### **ADDENDUM NO. 1 -**

**USC 1206 FLORA STREET MILL RENOVATION  
FIRE SPRINKLER BID PACKAGE  
Pre Bid Sign In Sheet**

University of South Carolina - Columbia, South Carolina

**State Project Number:** H27-I851 50003381-2  
**GMC Project Number:** ACOL180003

LEVEL 2 REFLECTED  
CEILING PLAN  
2-A2.01

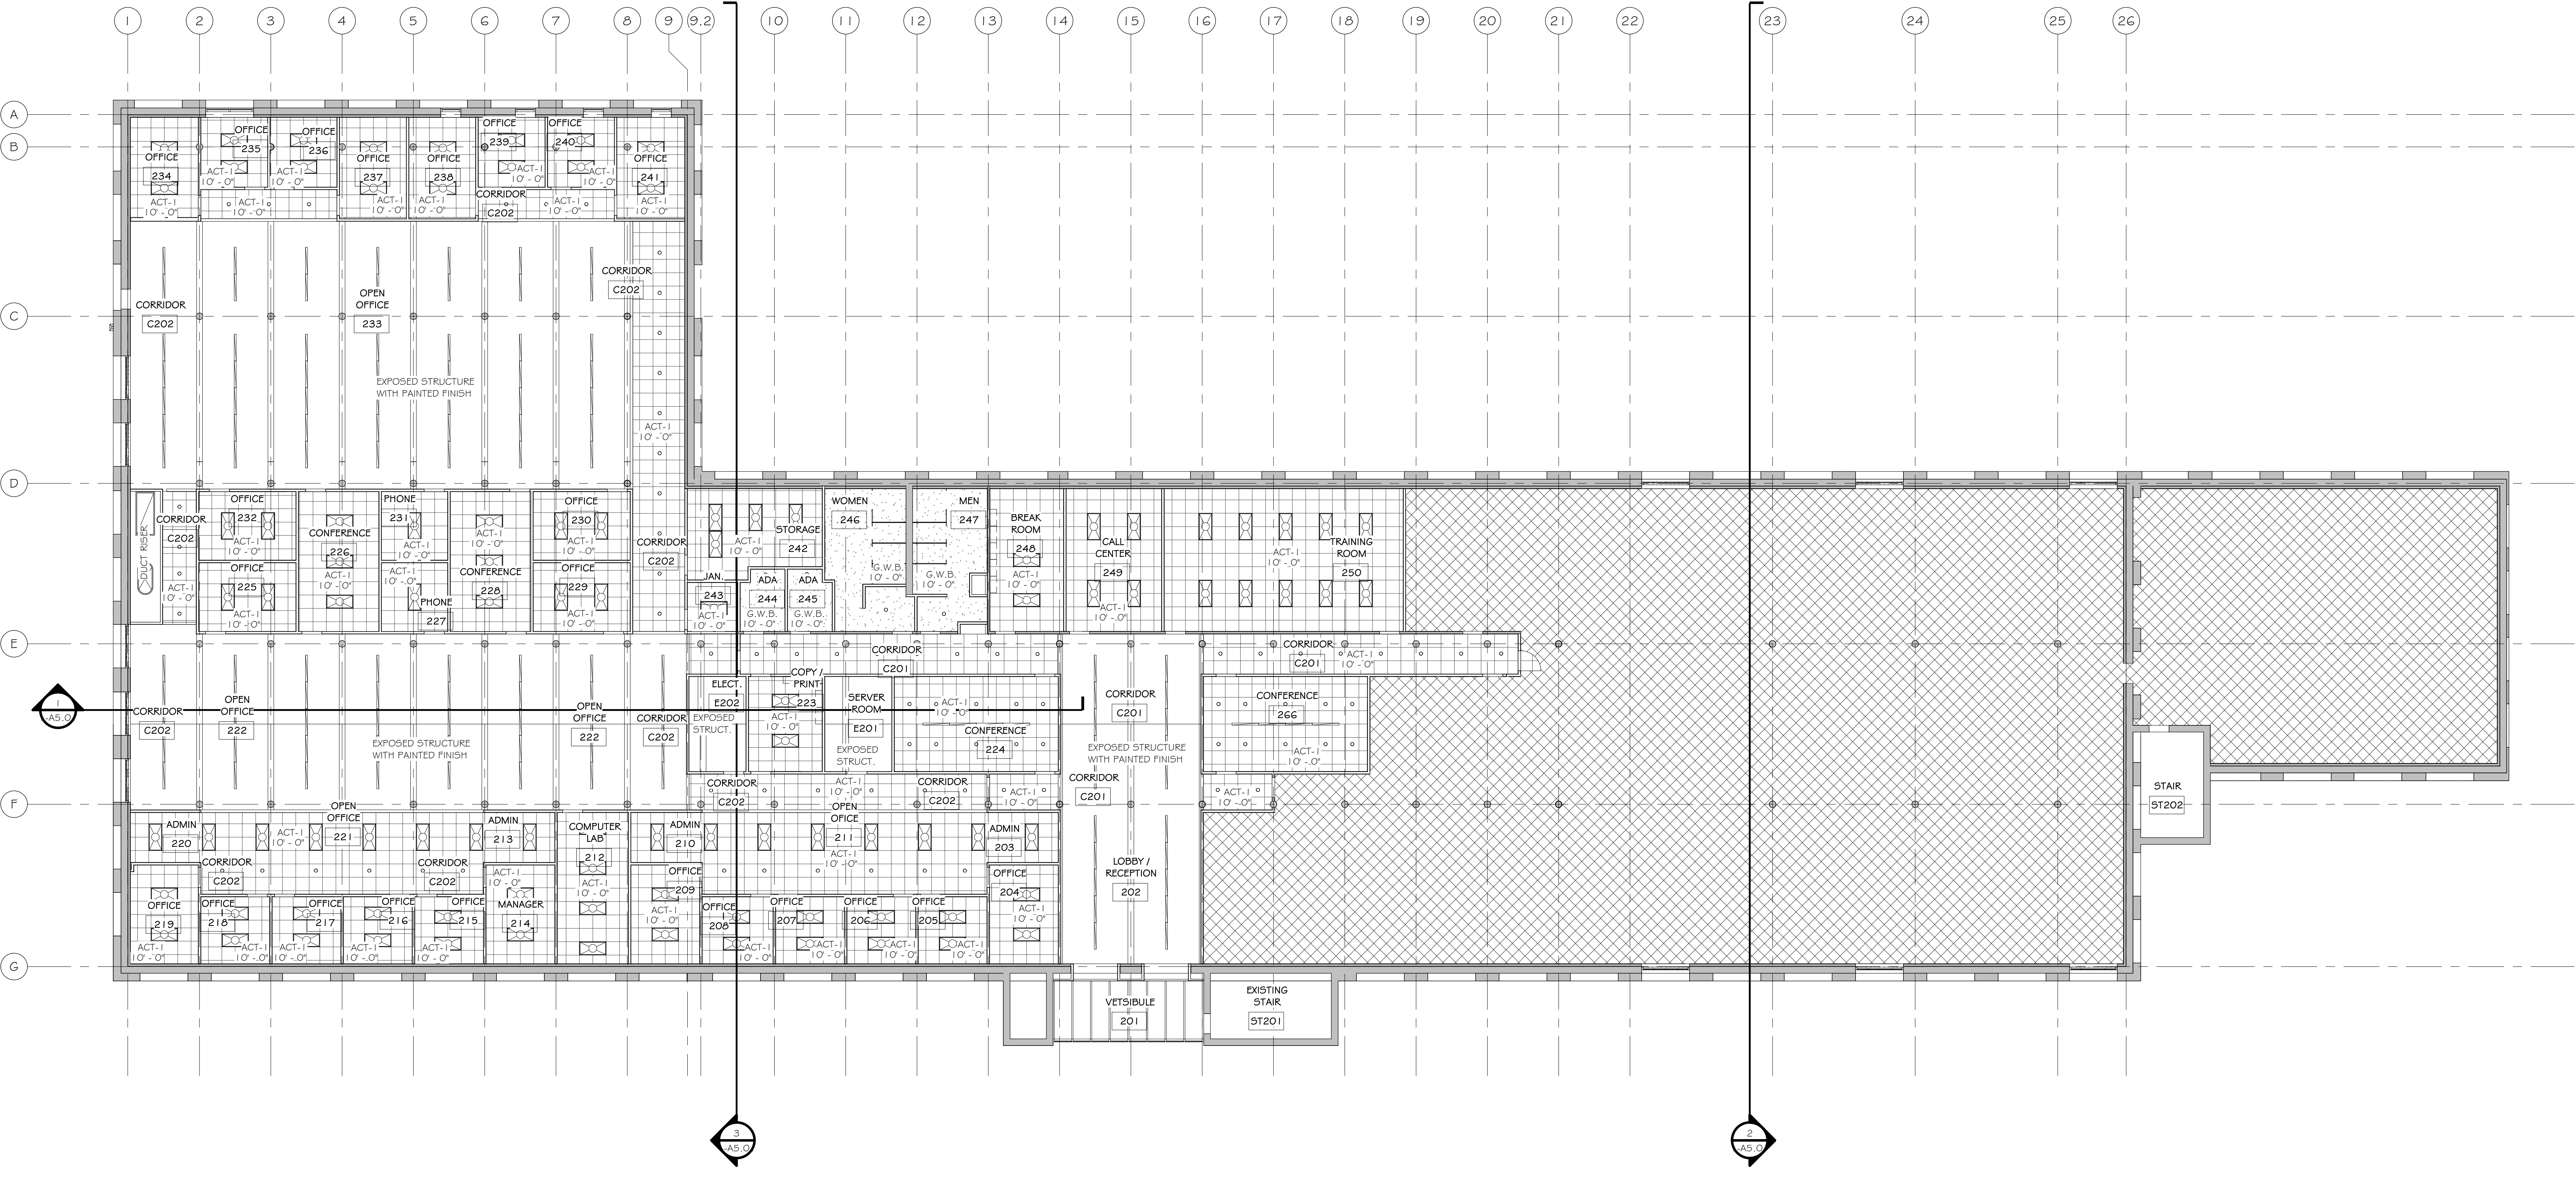
1. Pre-bid Sign-in Sheet
2. Floor Plans in CAD Format
3. Second Floor RCP (future upfit RCP provided for coordination with exposed structure areas)

**Response: The proposed strategy is acceptable and shall be included in the project pricing.**
5. (2) control valves & auxiliary drains supplying each half of the second floor can be placed anywhere as long as they are easily accessible.

**Response: The statement is correct. The location of the second-floor drains is flexible and shall work with the final floor upfit plan for the second floor. Locate Control valves and drains above drop ceiling areas and not in exposed structure areas.**
